UNITED STATES ENVIRONMENTAL PROTECTION AGENCY
REGION 2
290 BROADWAY
NEW YORK, NY 10007-1866

Re: Phillips 66 Co., Bayway Refinery, Linden NJ
EPA/NJDEP NJPDES Permit Compliance Evaluation Inspection June 12, 13, and 20, 2019
NJPDES Permit No. NJ0001511 (NJPID No. 46318), NJ0026671 (NJPID No. 46322)

**UNITED STATES ENVIRONMENTAL PROTECTION AGENCY
REGION 2, ECAD-WCB**

Program: Traditional NPDES		Inspection Type: Compliance Evaluation Inspection	
Permittee Name: Phillips 66 Co. Bayway Refinery		NPDES/ICIS No.: NJ0001511, NJ0026671	
Inspection Entry Date: June 12, 2019 Inspection Entry Time: 9:30 AM		Inspection Exit Date: June 20, 2019 Inspection Exit Time: 5:00 PM	
Facility Information: Phillips 66 Co. Bayway Refinery, 1400 Park Avenue, Linden, NJ 07036		Lat, Long: 40.6365 -74.219171° NAICS / SIC Code: 324110 /2911 petroleum refining and others.	
NJ PID No. 46318 (NJ0001511), 46322 (NJ0026671)			
EPA Representative(s): Murray Lantner, P.E. Environmental Engineer, EPA Region 2, DECA-WCB. (212) 637-3976			
State Representative(s): Andrew Coleman, Environmental Specialist III, NJDEP Central Bureau of Water Compliance & Enforcement, Mail Code 44-03, P.O. Box 420 Trenton NJ 08625 Andrew.C

DSCN6804 – potable water line leak inside the filter building

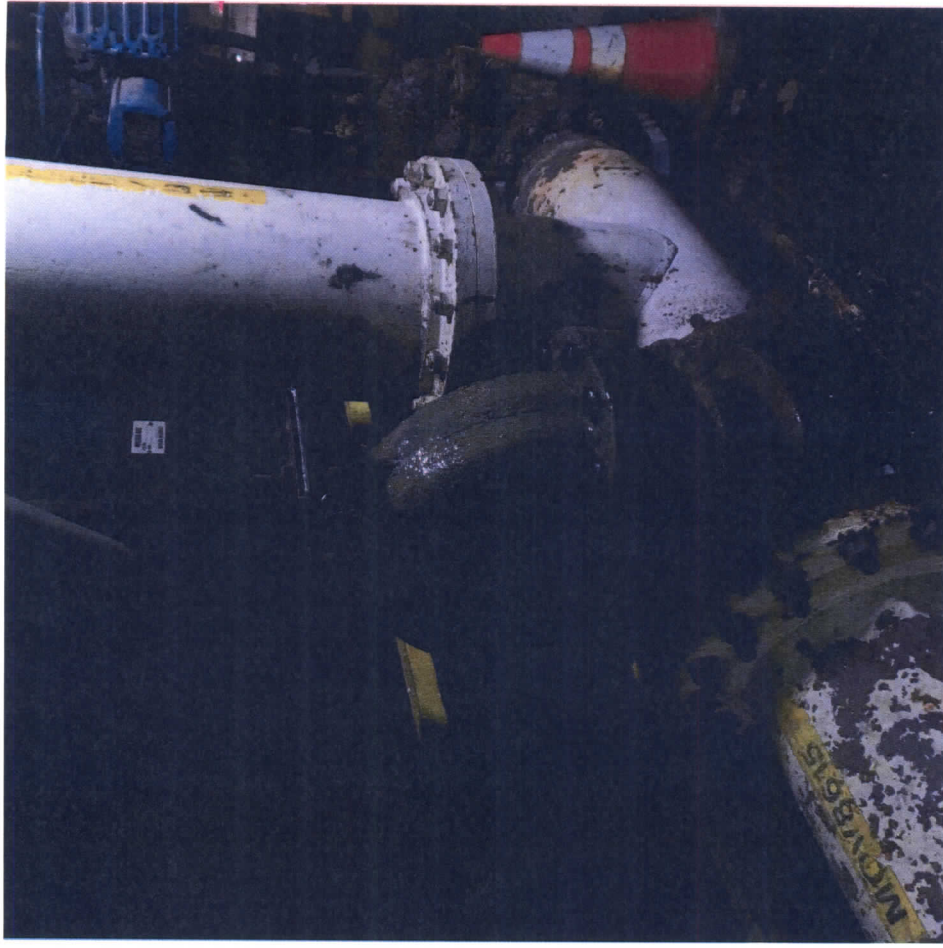
- b. As shown in photos 800 to 804 (Att.1b) there is a broken water line ((said to be operated by American Water) inside the filter building. Water is seen puddling and flowing outside of the filter building.

- c. As shown in photos 805 and 806 (Att. 1.b) there are gate valves associated with the filters that are leaking. The facility representative indicated that they were planning on replacing the gate valves with butterfly valves to eliminate leakage. Please provide the status of the gate valve replacement.

DSCN6914 – open dumpster with Polypropylene baghouse waste that could be blown out of dumpster – not covered

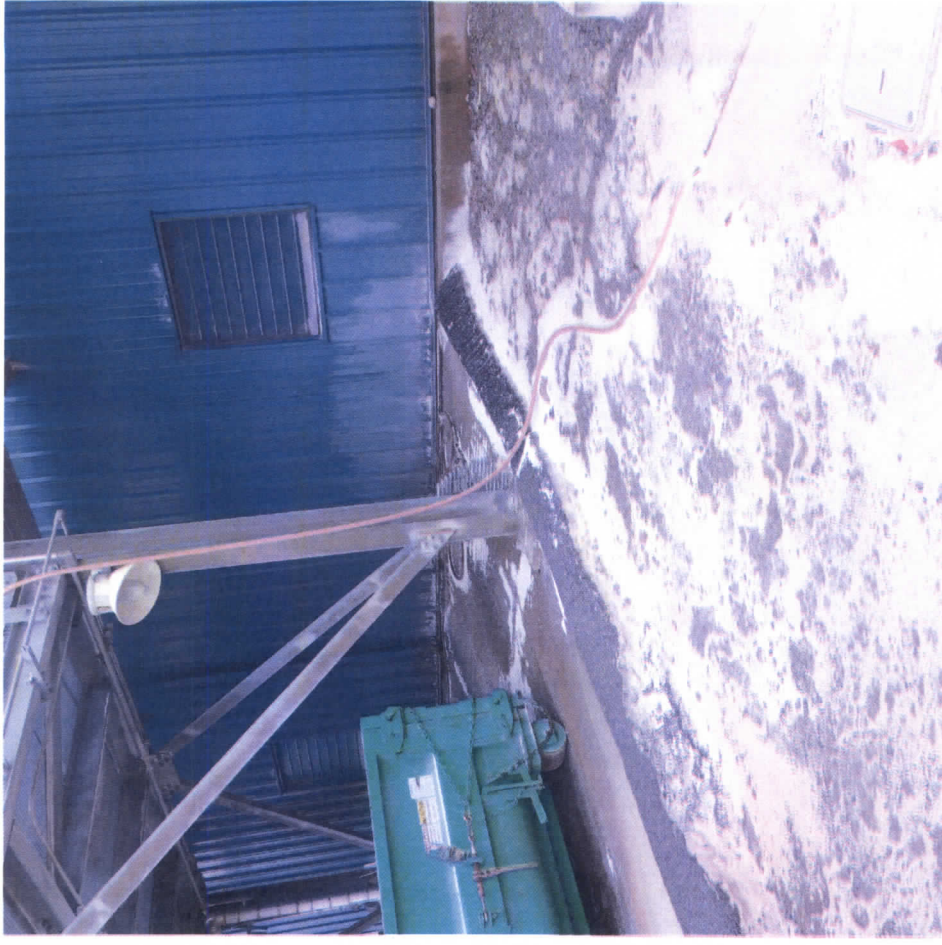
4	004		<p>d. As shown in photos 913 and 914 (Att. 1.c) there was an open dumpster receiving solids from the PP baghouse with waste polypropylene that could be blown out of the dumpster. Photos 916 to 923 show PP pellets on the ground in the area near the dumpsters and near an air intake system near the waste dumpsters. The Facility representative explained that these dumpsters, which collect material off of the PP baghouse, are kept open because the material inside the dumpster needs to be raked periodically. This dumpster should have a cover/or be within a contained area so that the waste Polypropylene pellets can-not be blown out of the dumpster or dumpster area.</p> <p>e. As shown in photo 918 (Att. 1.c) there was an open tote with waste material in it, waste containers should be kept covered to avoid stormwater contamination.</p>	AOC
		929 to 932 Att. 1.c	<p>As shown in photos 629 to 632 there was scum seen floating inside the booms at the Poly Ditch Outfall 004. The Scum was thought to be associated with the Clam-Trol application that was conducted earlier in the day. The Facility representative said that a Vac truck would be brought in next shift to remove the floating scum at Outfall 004. NJDEP, in its subsequent inspection report, required that Best Management Practices be developed for the collection and removal of material at Outfall 004 during and after Clam-Trol application.</p>
